Access Compliance Report

Public Rights-of-Way

(Curb Ramps)

Intersection ID: 14340	Main Street: KENILWORTH_AV	Cross Street: GREENWOOD_CLIFF	Location: NW
ADA ID: B008559930CB	Ramp Type: Combination2	Initial Pass/Fail: Fail	Overall Compliance: No
			Severity Score: 26.25

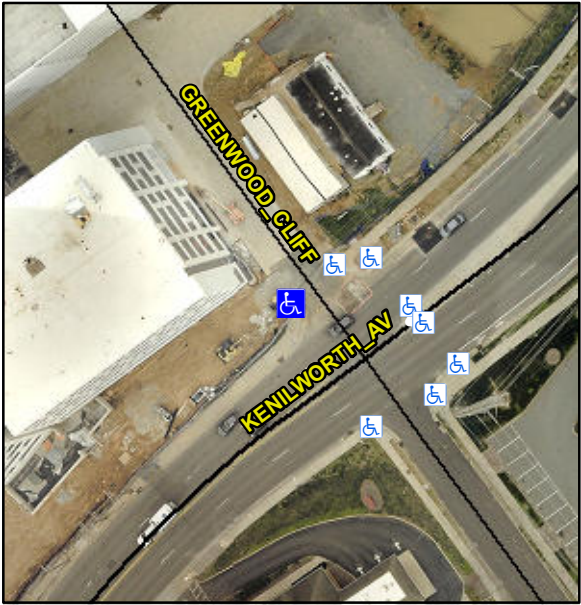
Codes/Mitigation Info/Possible Solution			Field Measurements/Component Compliance		
	Possible Solutions:		Compliance	Description	Data
	Remove & Replace Entire Ramp.		Compliance	Description	Data
			N/A	Ramp Length LT (in)	39.0
			Yes	Ramp Width LT (in)	58.0
			No	Ramp Slope LT (%)	12.3
			Yes	Ramp XSlope LT (%)	0.6
			N/A	Ramp Length (in)	28.0
			Yes	Ramp Width (in)	48.0
			N/A	Flare Type LT	N/A
			N/A	Flare Slope LT (%)	N/A
<p>Surveyor Notes:</p> <p>N/A</p> <p>PROW/ADA:</p> <p>Not Found, R304.5.3, R304.3.2</p>			N/A	Flare Type RT	N/A
			N/A	Flare Slope RT (%)	N/A
			N/A	Flare Traversable LT?	N/A
			N/A	Flare Traversable RT?	N/A
			N/A	Landing Length (in)	N/A
			N/A	Landing Width (in)	N/A
			N/A	Landing Slope (%)	N/A
			N/A	Landing X Slope (%)	N/A
			N/A	Landing Curb? (Y/N)	N/A
			N/A	Shared Landing?	N/A
<p>Street 1 Name</p> <p>Stop Condition-Street 1</p> <p>Street 2 Name</p> <p>Stop Condition-Street 2</p>			N/A	Gutter Ponding?	N/A

N/A	Gutter Lip Ht (in)	N/A
			N/A	Painted X Walk1?	No
				X Walk 1 Direction	To NE
				X Walk 1 Width (in)	N/A
				X Walk 1 Slope (%)	1.4
				X Walk 1 X Slope (%)	4.1
			N/A	Ramp inside XWalk1?	N/A
			N/A	Road Slope (%)	N/A
			N/A	Road X Slope (%)	N/A
<p>Total Cost:</p> <p>\$ 1600.00</p>			N/A	Ramp inside XWalk2?	N/A
				Clear Space?	N/A
			N/A	Clear Space to XWalk (in)	N/A
			N/A	Any Obstruction?	N/A
				Obstruction Type	N/A
					N/A
			N/A	Storm Grate/Utility Hazard?	N/A
				Storm Grate/Utility Type	N/A
					N/A
			Yes	Surface Condition? (G/P)	Good
				Curb Slope (%)	18.2
